## **RE:** ALEXANDRIA WEST SMALL AREA PLAN DRAFT RECOMMENDATIONS

RE: 4550 Kenmore Ave., TM 020.04-01-01 ("Seminary Plaza") Owners' Comments on Alexandria West Small Area Plan Recommendations

## Re: Alex West SAP Newport Village

# **Proposed Diagram**

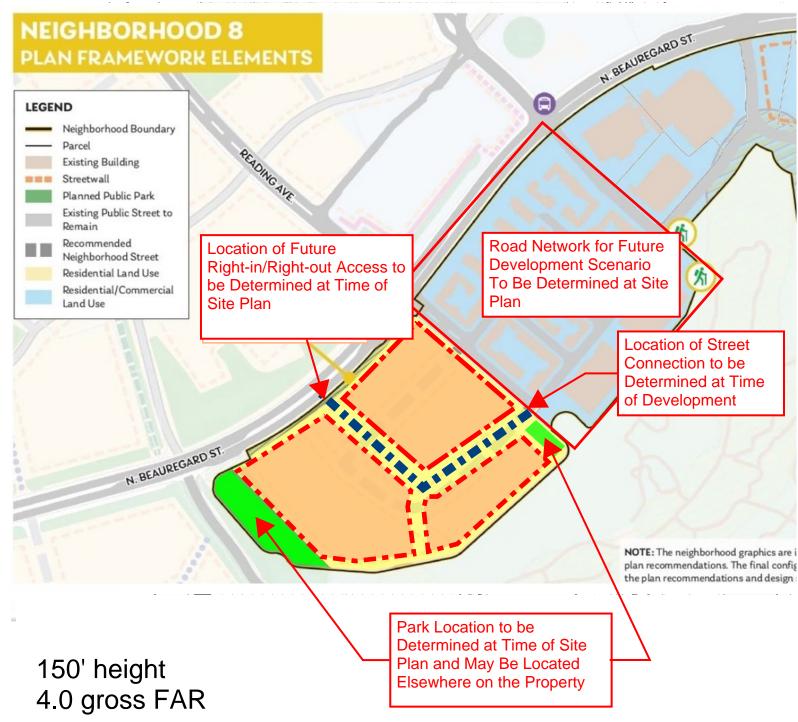
Open Space: The draft plan graphic identifies two open spaces on the Property; Park 15 (an 8,000-sf. pocket park) and Park 16 (a 45,000-sf. natural and conservation park). Open space will be provided on the Property in any redevelopment scenario, although the specific location of the open space will not be determined until the Property is redeveloped. Park 16 is accompanied by the note 'Maintain the area of steep slopes to enhance the entrance to the Winkler Preserve'; however, Park 16 is located in an area that has been constructed upon and currently contains a structure, and an intervening parcel (#029.03-01-06) exists between the South Parcel and the entrance to Winkler Preserve. The steep slopes that are referred to in this note are located on an adjacent parcel, outside of the South Parcel. Please remove this language from the draft plan.

Accordingly, we ask that you replace the note for Park 16 and Park 15 with language that reads 'Park Location to be Determined at Time of Site Plan and May Be Located Elsewhere on the Property' and modify the typology for Park 16 to 'TBD'.

<u>Beauregard Connectivity</u>: The draft plan does not show future access from the South Parcel to Beauregard Street; it is important that an option for a future right-in/right-out access to Beauregard be permitted to provide for adequate future connectivity. <u>Beauregard Connectivity</u>: The draft plan does not show future access from the South Parcel to Beauregard Street; it is important that an option for a future right-in/right-out access to Beauregard be permitted to provide for adequate future connectivity.

Please adjust the graphic to illustrate an access from the South Parcel to Beauregard Street, and please add a note that reads 'Location of Future Access to be Determined at Time of Site Plan'.

Please add concept level detail to illustrate that redevelopment of the North Parcel is contemplated and add a note that reads 'Road Network for Future Development Scenario To Be Determined at Site Plan'. We have added a note to the North Parcel on the attached graphic and will work with you to create a concept level non-binding development pattern for the North Parcel.

<u>Interparcel Connectivity</u>: The draft plan illustrates a connection between the North Parcel and the South Parcel; we concur that the two parcels will have a vehicular connection in the future, although it cannot be foreseen exactly how this connection will occur and we request that staff add a note to underscore the necessary flexibility for the location of the connection.

# *Please add a note that reads 'Location of Street Connection to be Determined at Time of Development.'*
